ADDENDUM #7

Nesbett Courthouse Clerks Office Remodel Project No. ANC-C-25-0009

Date: April 18, 2025

C1 **ENLARGED PLAN - APPEALS 107 & 108**
 1/4" = 1'-0"

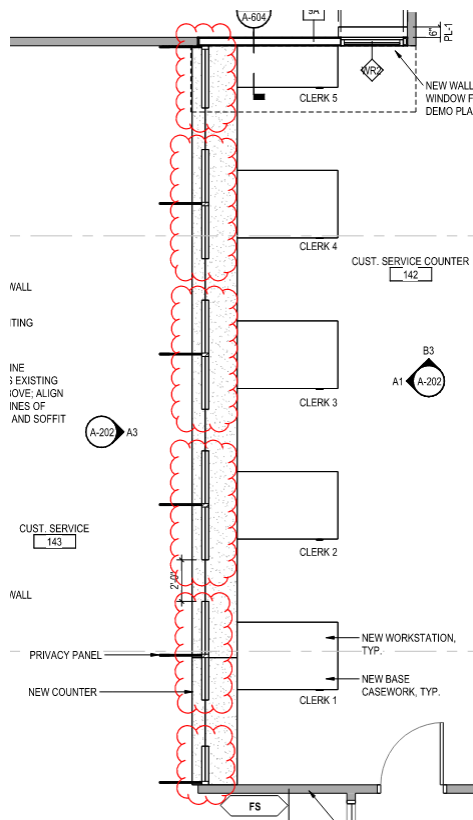
1. Drawing No. A-201, C1 Enlarged Plan – Appeals 107 & 108: For the new workstation and service counter, interior partition type 93 is called out once for the Appeals 107 service counter. Should contractors assume that partition type 93 also applies to the Appeals 108 service counter? See outline below:

Above the clerk counters there is not partition, only a gypsum ceiling soffit. The partition below counter stops at the underside of the counter and is type 93. Above the counter are vertical support mullions between each station and a sill. The acrylic panel is supported by the mullions and the sill. Above the acrylic and below the gypsum ceiling soffit is open for air flow.

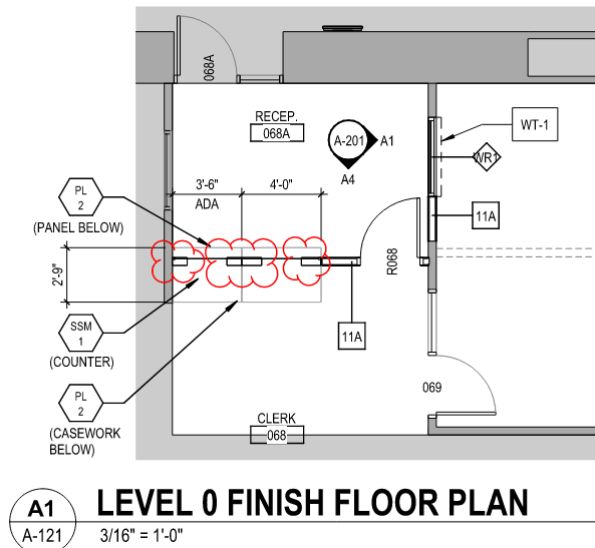
2. Drawing No. A-202, B1 Enlarged Plan – Clerk Service Counter 142: No interior partition type is called out for the new counter. Should contractors assume that partition type 93 also applies to the Clerk service counter? See outline below:

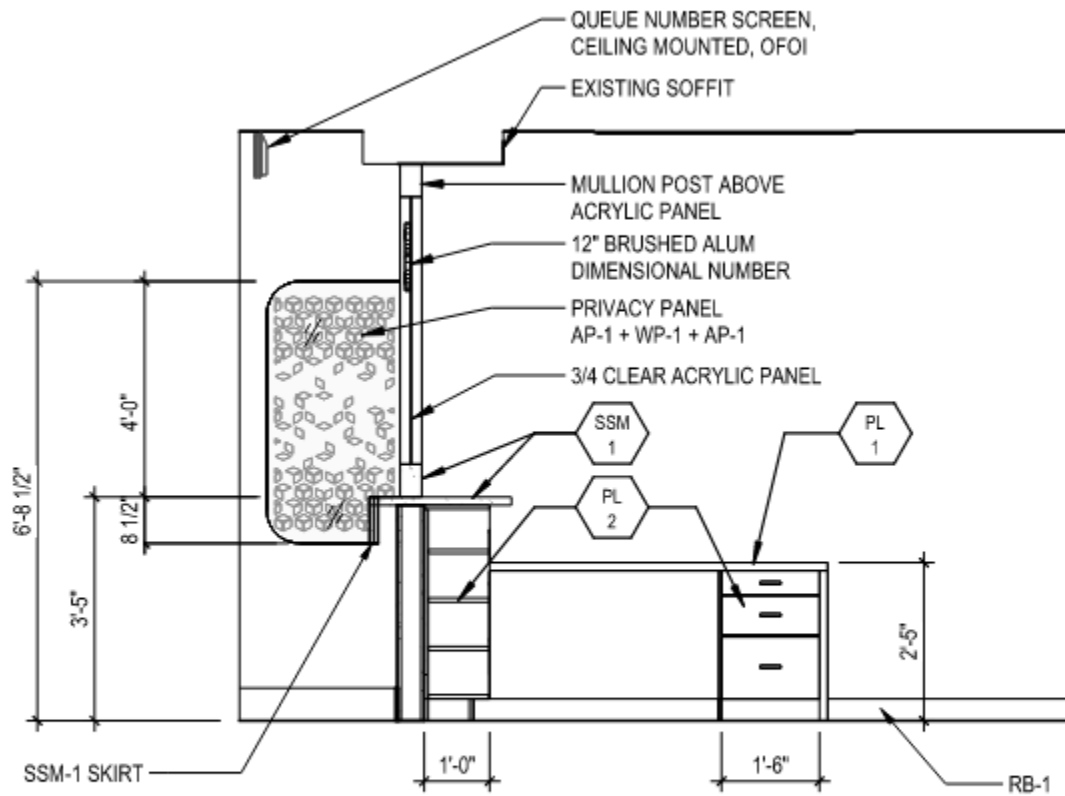
3. Drawing No. A-121, A1 Level 0 Finish Floor Plan – Reception 068A Counter: No interior partition type is called out for the new counter. Should contractors assume that partition type 93 also applies here? See outline below:

B3
A-202

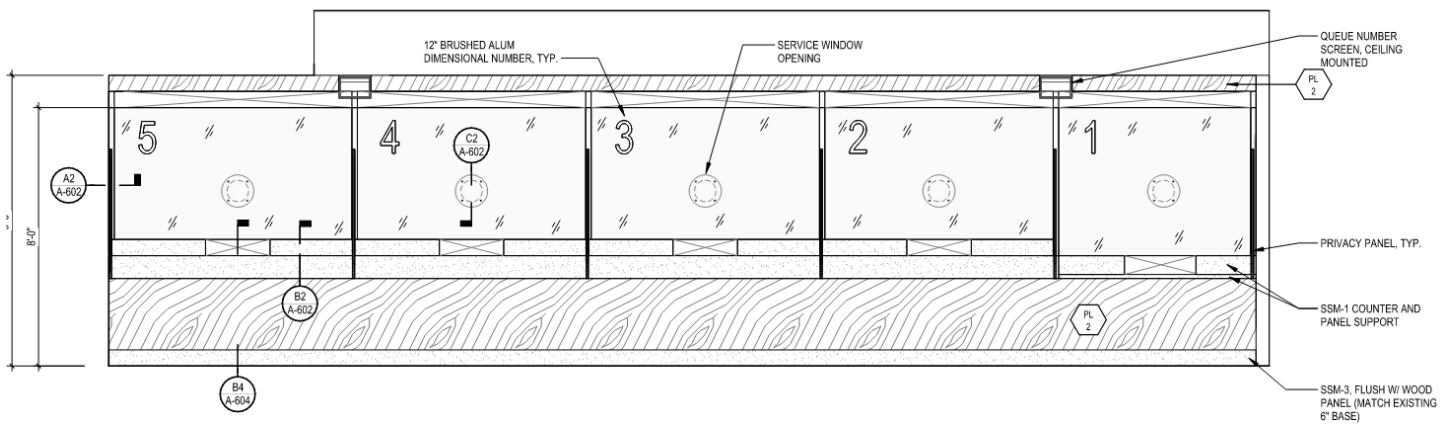
4. It would also be helpful to clarify the wall assembly requirements **above** the counters, not just below.
5. In other words, please provide a clear definition of the required wall assemblies for **all** new wall construction—from the finished floor elevation up to the ceiling. For example, some wall type callouts appear only at partial-height walls, such as at clerk or service counters, but the wall assembly above the counter or window areas is not clearly defined.

B3/A202 show the section view at the counter.

A101D

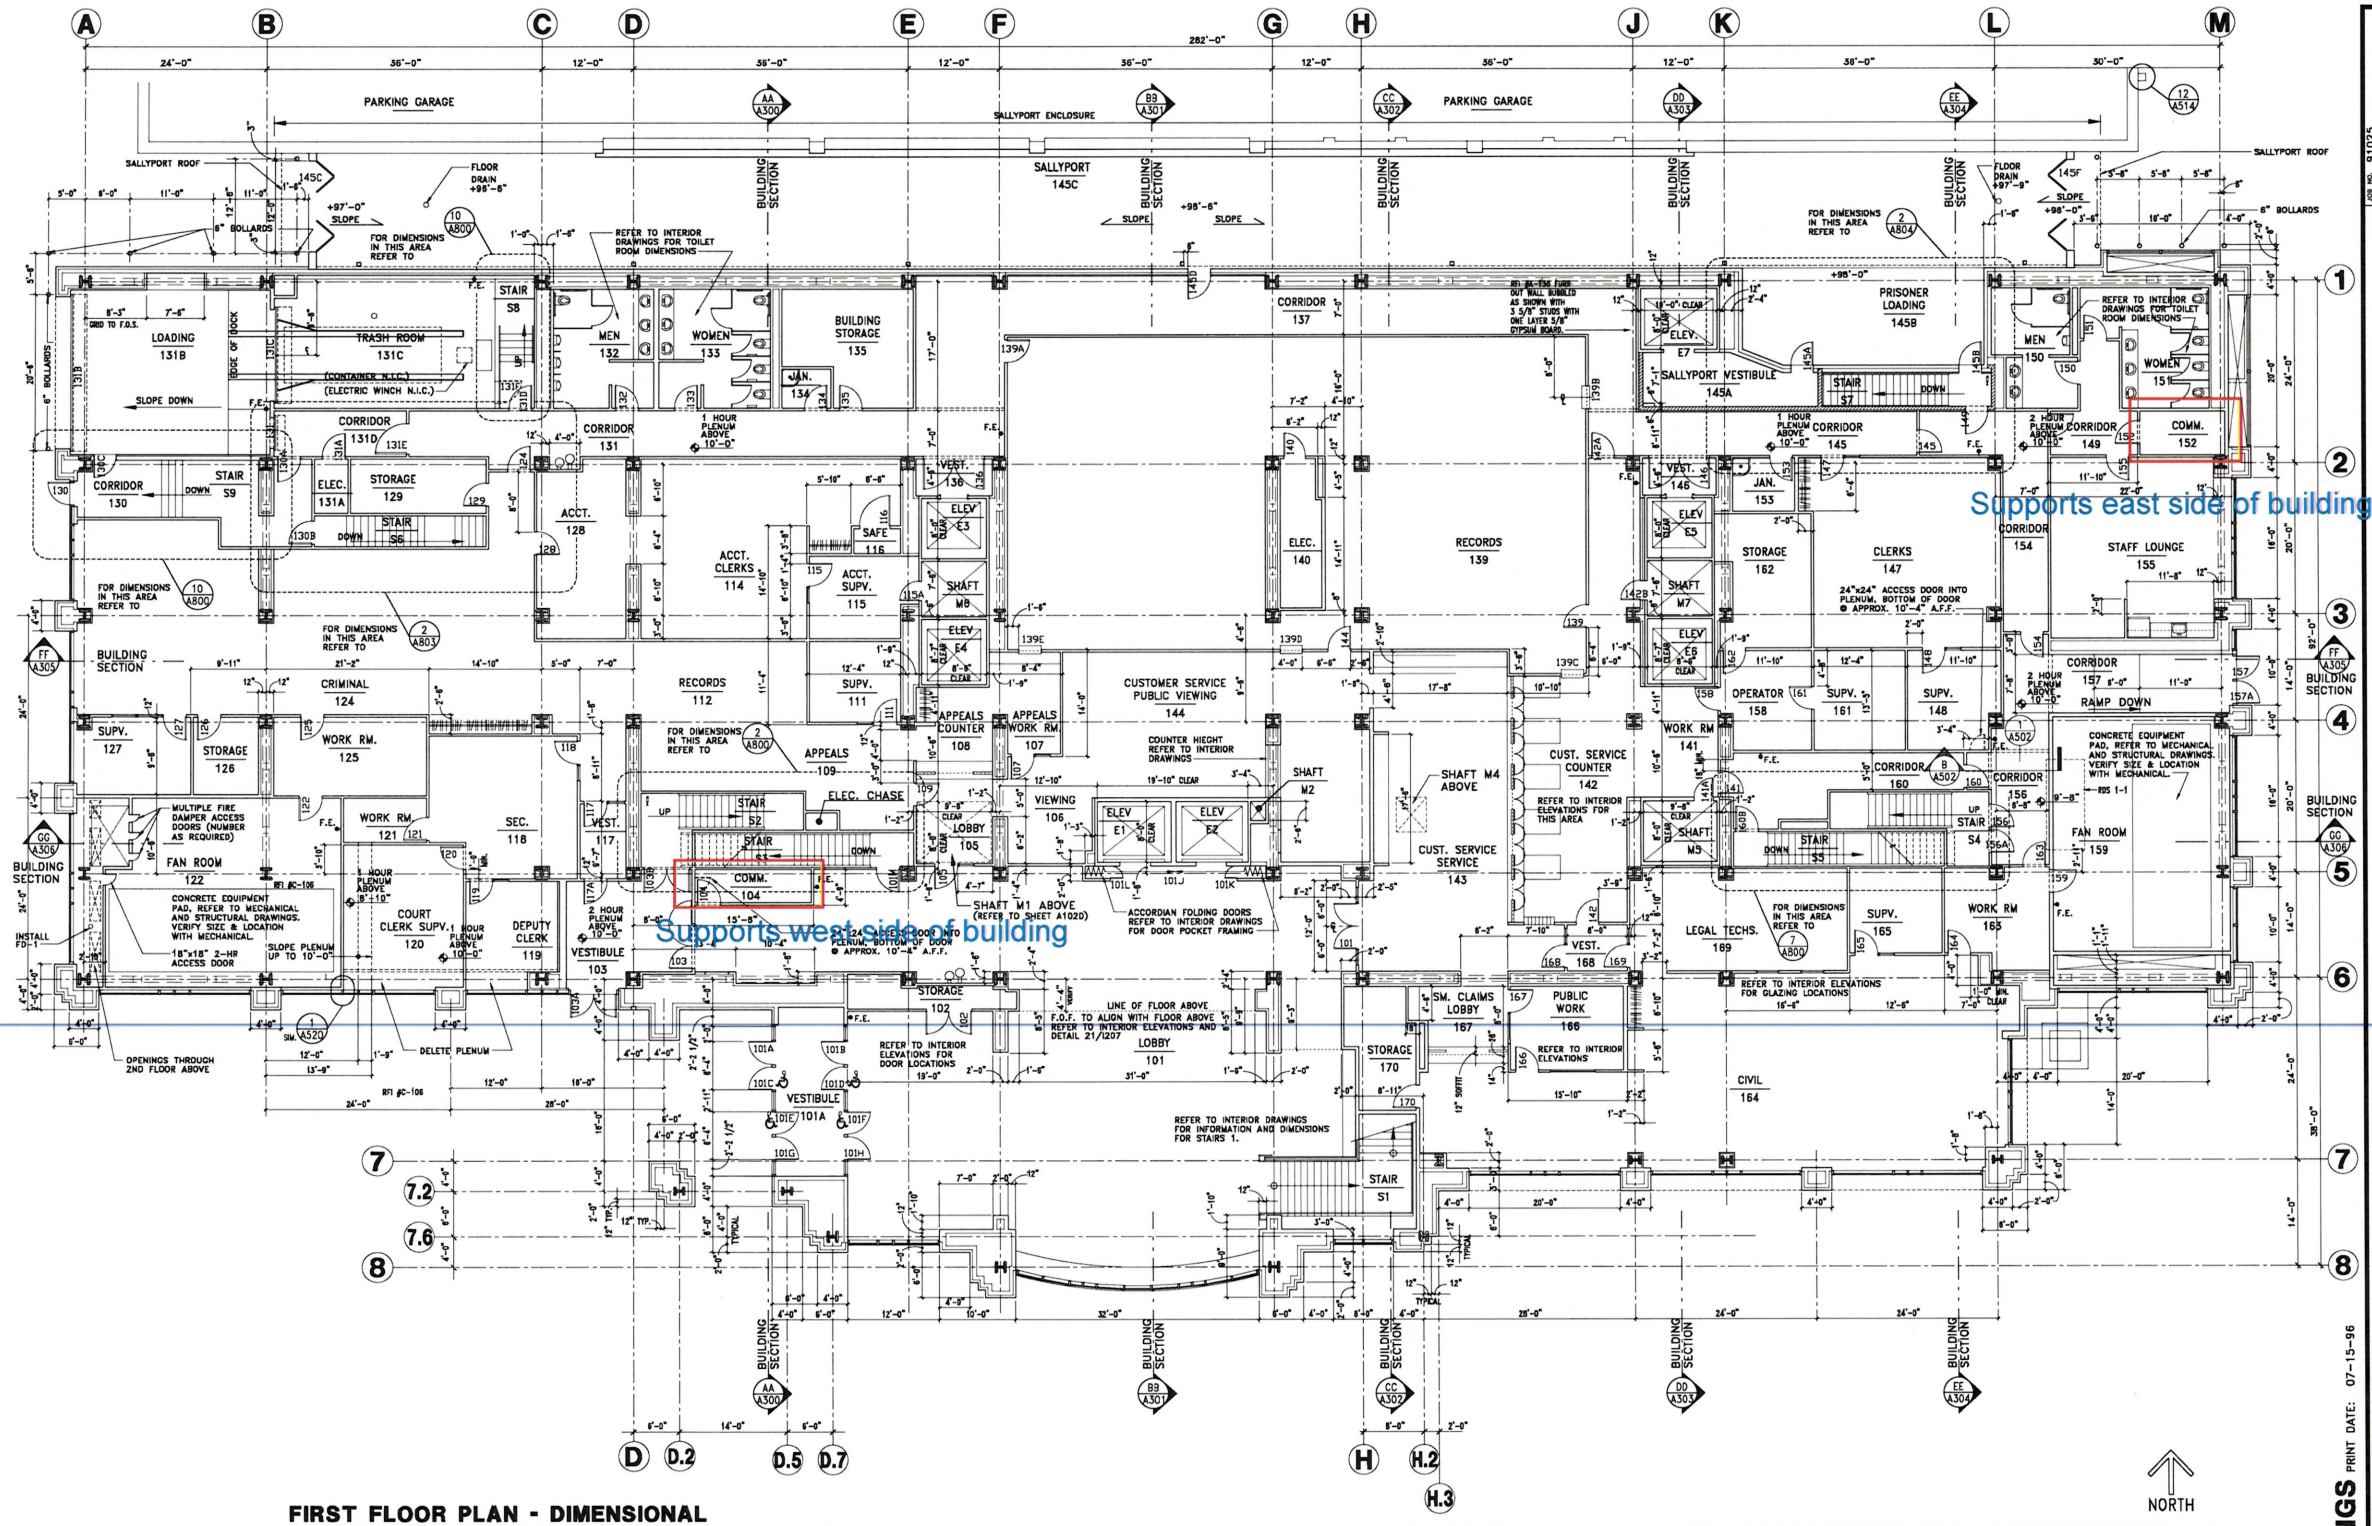
Where are the Comm Closets

Response: See attached Nesbett As-Built – Sheet A101D
